Department of Planning and Zoning

TO: Development Review Board
FROM: Scott Gustin & Mary O'Neil *MO*
DATE: February 18, 2014
RE: 14-0671CA/MA; 194 St. Paul Street
14-0672CA/MA; 1 Browns Court
14-0721CA/MA; 14 Browns Court

Request: Construction of mixed use building with ground-floor commercial space, 115 residential units and enclosed parking. Development to merge three existing lots.

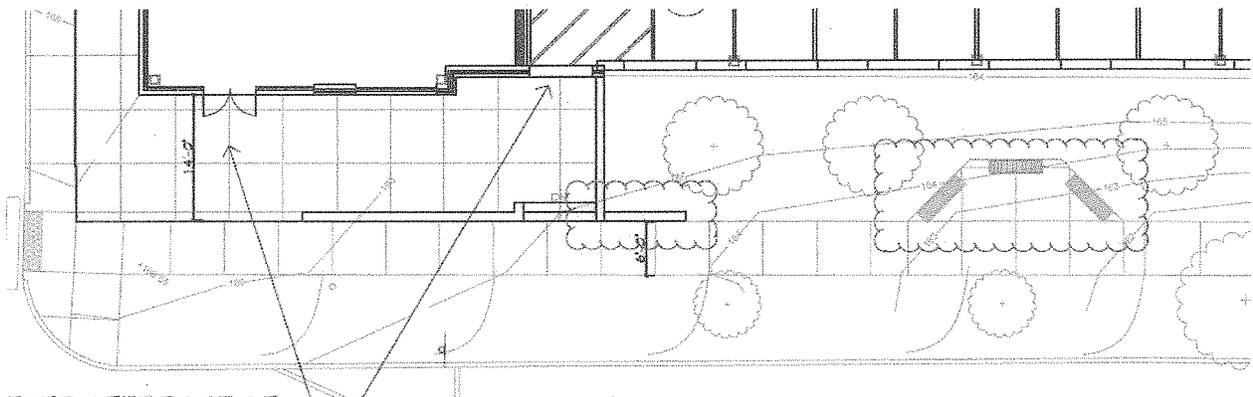
A landscaping plan has been provided (Sheet Number C6.) At the end of Brown's Court, a 4' high solid fence and gate (set on top of a 2' high wall) is proposed to screen the dumpster. The corner of the dumpster is approximately 6' from the abutting property line on the north.

An aggressive planting plan is proposed for the west and south elevations, in part to soften and screen the garage fronts, to activate the building front, and to warm the pedestrian experience along these lengths of the building. Sidewalks are proposed to be widened (undetermined width at this point – at least 6' wide; more if existing infrastructure is not an impediment.) A "bump-out" is proposed for the bus access area on St. Paul Street, which will be enhanced as a patio-area with seating. One existing street tree is proposed to be removed for the Maple Street garage exit.

Doing so shall be subject to the approval of the city arborist. **(Affirmative finding as conditioned)**
